Strengthening of connecting lap of forked airbrake push rod in fuselage.

Leistungseinsitzer
Schleicher K 8
Bearb. R. Kaiser 13.9.62.

Zeichnung zu
Änderung Nr. 9

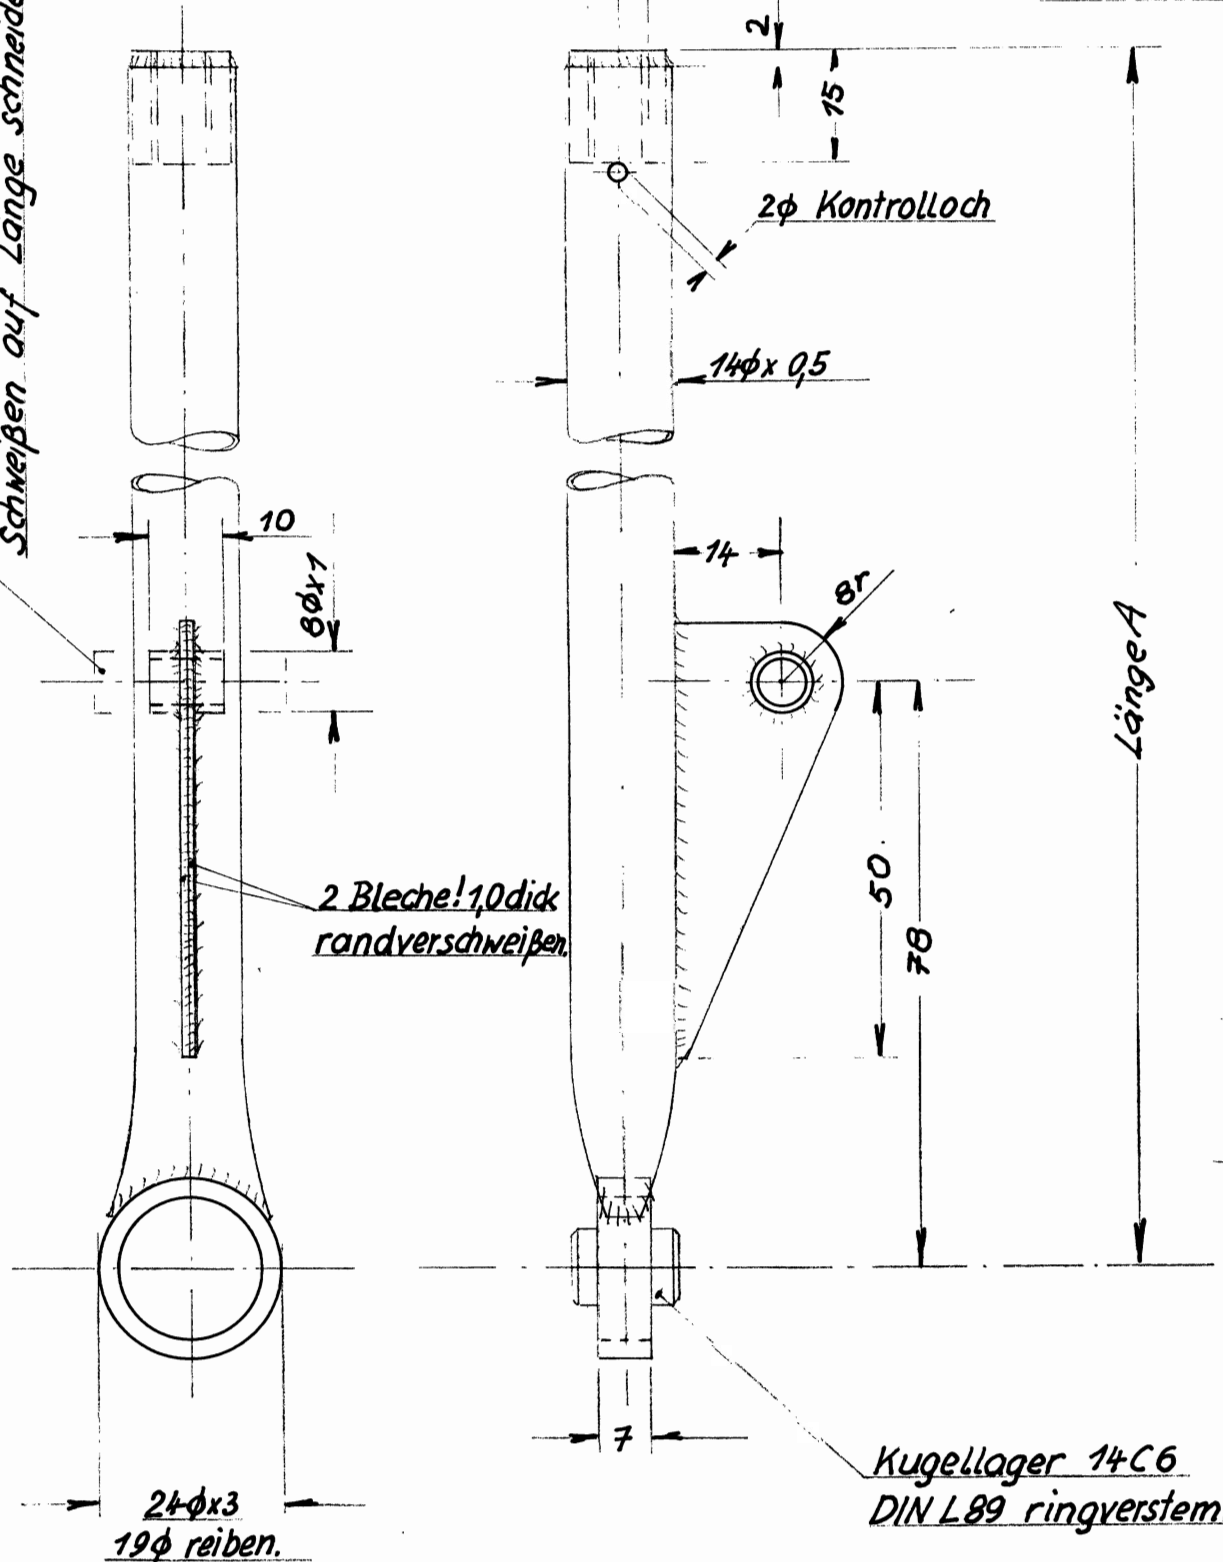
There have been found cracks on several pieces as shown in figure.

- 1.) The pushrod I) is to be build out and replaced by a modified one. Secure all screws and pins by split pins properly. The quick - connecting head is to be adjusted at the assembled glider and secured by the nut. Check proper closing of both airbrakes!
- 2.) The modified pushrod is to be ordered by the Firma of A. Schleicher or one of the License firms. The distance A) must be given exactly when ordering.

- 3.) The modification is made from S.No. 8099 incl.
The modified push rod has 2 plates 1,0 mm thick. A few samples are modified with a thick 1,5 mm thick plate, this is taken as equivalent.

Rohr länger lassen nach dem
Schweißen auf Länge schneiden.

M8 zunderfrei. Erst schweißen, dann
schneiden.

Werkstoff:
Stahlrohr St. 35.29
Stahlblech Fl. W. 1604
od. 1.72 14.4
